DA No: DA2020/0855

Modification of Development Consent

***‘Demolition works, alterations and
additions to the existing dwelling
house with new pool’***

**83-85 Bower Street,
MANLY**

Figure 1: Extract of lower ground floor level, showing the three building envelopes – existing, approved and proposed (s4.55 plan set, dated March 2021)

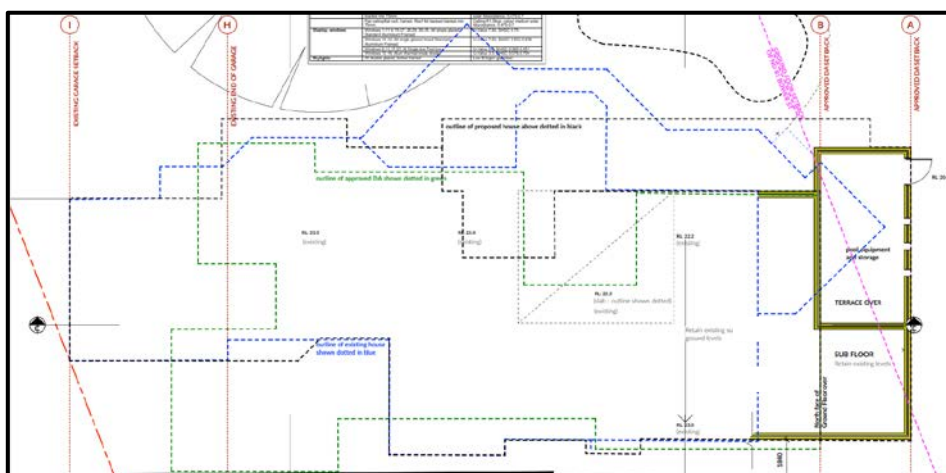
- 2.1 The S4.55(2) proposal seeks approval to carry out alterations and additions to the approved dwelling whereby elements of the existing house are retained below the first floor level. The total amount of the existing structure retained is now 28% as opposed to full demolition. We also note that with 28% retention of the dwelling it is not possible to lodge an application for a alterations and additions to a dwelling and accordingly a DA proposing to retain 28% would be categorised as a new dwelling just like the current amendment. Some particulars of the S4.55 proposal are provided below:

- Maintained fabric includes the existing attached garage on Montpelier Place, the ground floor bedrooms & bathrooms on the eastern side of the site. The existing pool is now retained and used as a stormwater detention tank, with landscaping over the top of the retained pool.

- All of the existing first floor is demolished.
 - Of the 358m² of existing floor area, including the attached garage, 101m² is being retained. This equates to 28% of the existing dwellings fabric.

Figure 3b: Northern Elevation (s4.55 plan set, dated March 2021)

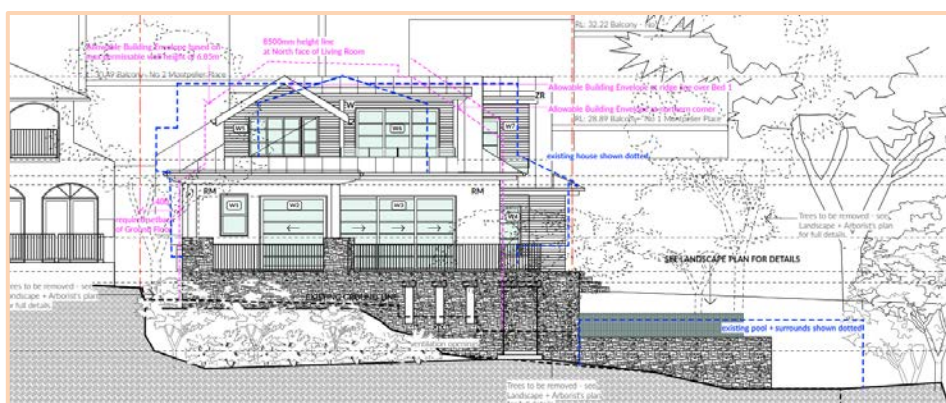
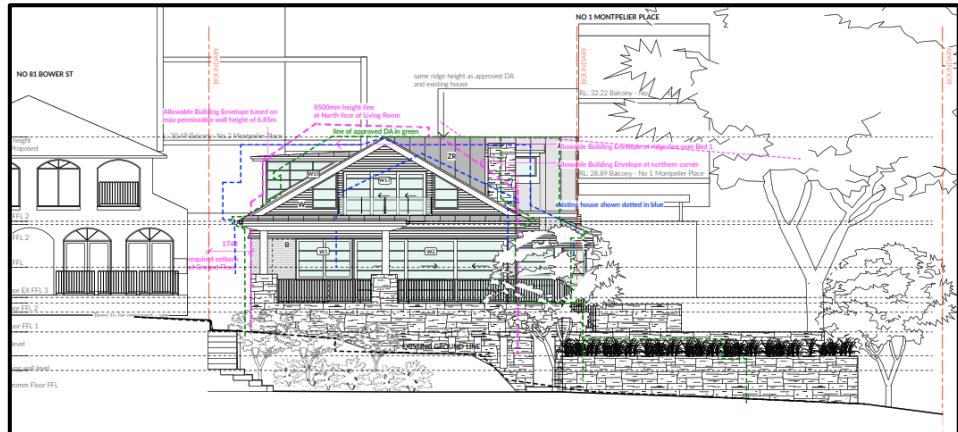
- The facade presents in similar form to the approved scheme – two main gables facing west into the garden, one gable over the garage facing Montpelier place and one gable form facing north over the main bedroom.

- The proposal remains oriented away from the eastern boundary, continuing to minimise any overlooking of No. 81 Bower St. There are no living rooms windows at first floor level where the only windows are the bathroom (over 6m from the boundary. Sills are 1.9m from the finished floor level of FF.

Figure 5b: Eastern Elevation (s4.55 plan set, dated March 2021)

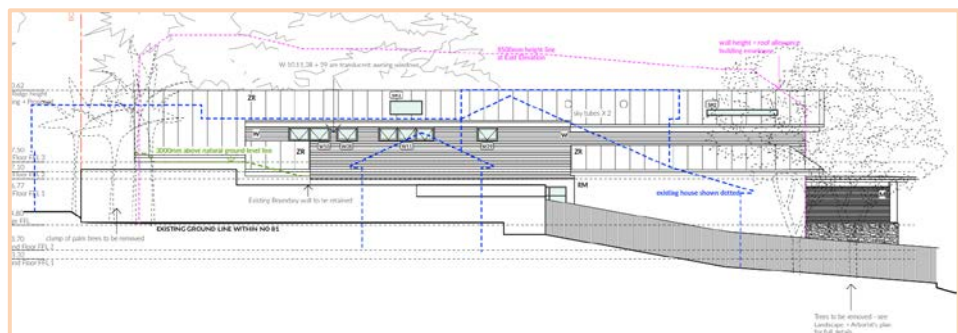
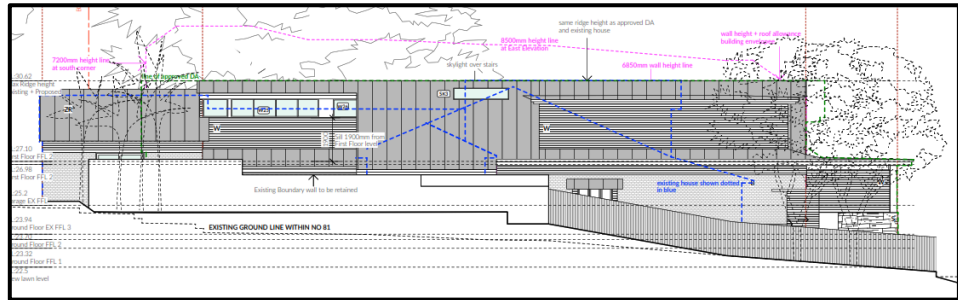
An assessment of the changes along the eastern side of the dwelling reveals that the redesign has adequately considered any anticipated impacts on the eastern neighbour.

Figure 7: Extract of Landscape Master Plan (s4.55 plan set, dated February 2021)

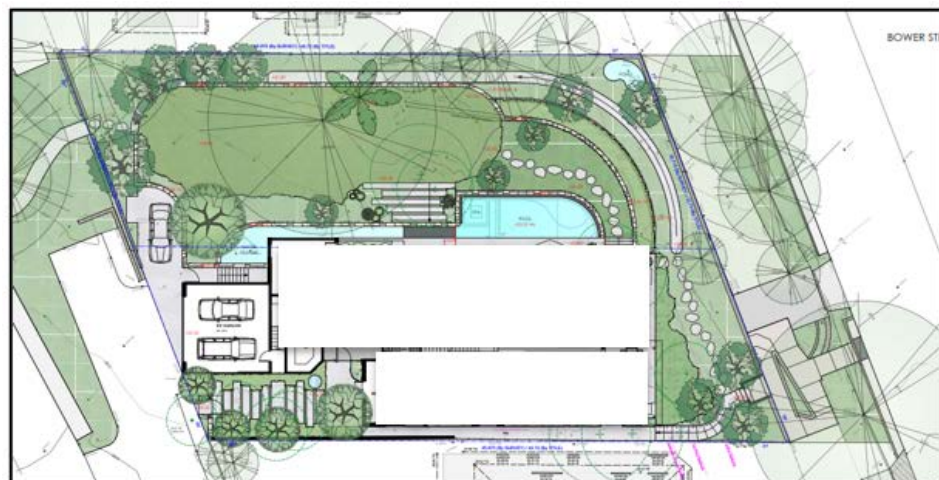
- The external wall material of the ground floor new works remains as face brick.
 - The shape of the new swimming pool and spa is modified; location generally the same.

- Addition of a long water feature– from the western side of the entry stairs to the edge of the spa.
 - No change to the roof, weatherboard walls or window materials as the spec remains as approved.

3.5 Sustainability	<p>A new BASIX certificate has been provided with the proposal.</p>
<p>3.5.5 Landscaping</p> <p>3.5.5.1 Considerations in Plant Selection and Landscaping Design</p>	<p>A revised Landscape Plan is submitted reflecting the outdoor changes to the development eg shape of the swimming pool and spa, the water feature, the eastern front entrance. The planting scheme is generally unchanged.</p>
